Feckenham Parish Council

23/00192/FUL Cross Boundary Application for Solar Farm Cable - Redditch LPA W/23/00270/FUL Solar Farm Application – Wychavon LPA

Assessment of Harm from the Cable Installation

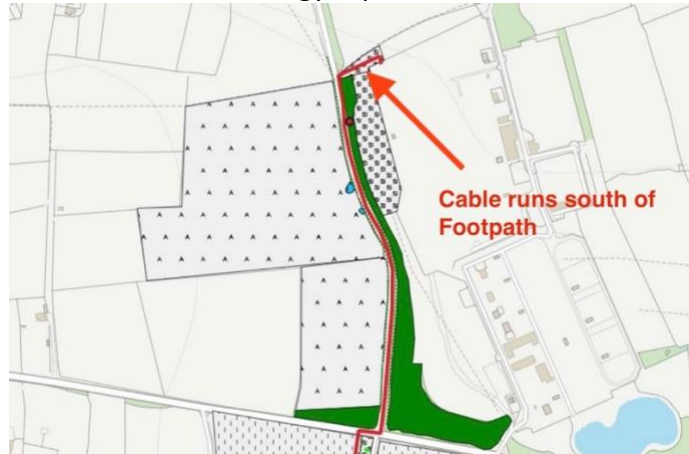
3. In fact, JBM have included very clear diagrams showing that a trench measuring 1.6m deep and 0.7m wide, will be dug the entire 4.5km length of the cable. We show some of these diagrams below. Note there are, in fact, two triple core high voltage cables, two earth conductors, and two comms conduits sited in the trench; and, importantly, the construction includes the removal of a layer of soil 0.6m in depth, and its replacement with sand bedding. The officer incorrectly says a "pipe" is being installed and she should know that it would be completely impossible to construct this complex layout shown below using "mole" technology.

5. We point out again that the applicant states that the width of the construction area is 10m, and given the complexity of the construction, as detailed above, we anticipate that this will be fully utilised by multiple types of heavy equipment, all of which are likely to damage the soil surface. Multiplying the width of the construction area (10m) by the length of the trench (4.5km) length gives the approximate size of historic pastureland which will be affected by this cable laying operation – 45,000 square metres. Much of this contains precious and irreplaceable Ridge and Furrow soil formations.

The archaeology officer appears to have completely misunderstood JBM's proposed construction techniques and the sheer scale of this operation. Specifically, we think her mistaken assumption that "mole" technology will be used, has led her to vastly underestimate the potential damage to important heritage assets. We would respectfully request that she reconsider her opinion accordingly.

Map of cable route in Ecology report: Trees would be damaged.

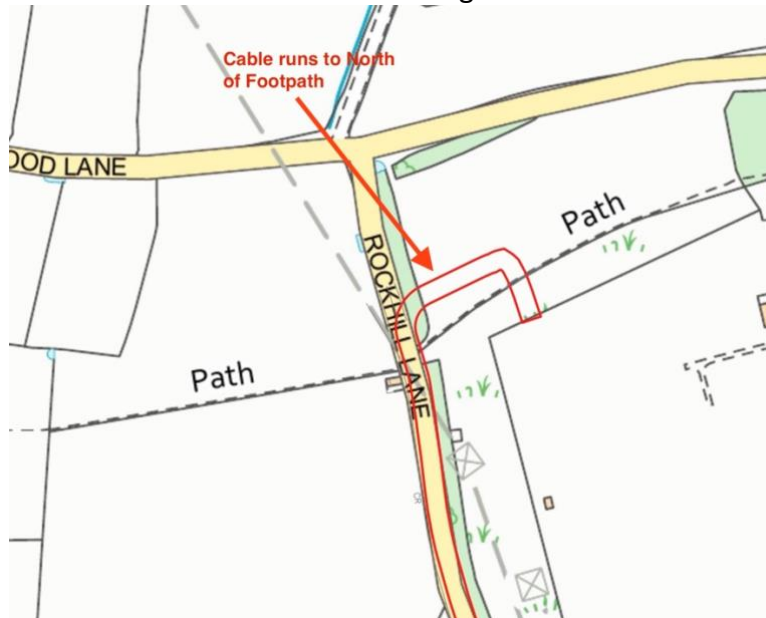
It has come to light that there are some inconsistencies and inaccuracies in the information about the cable route supplied by the applicant to Redditch and Wychavon LPA's. Although this is a small matter, when compared to the magnitude of the whole application – it remains the case that unless the relevant details are consistent, then both applications are potentially invalidated. In this regard we point out that, the cable route near the substation is recorded on the Redditch website Ecology documentation as running south of the PROW footpath, whereas in the "cable route" diagrams it runs to the north of the same footpath. This matters because there are several trees that would be sacrificed if the "Ecology diagram" route was to be followed. We ask that the applicant clarify where the cable will be sited.
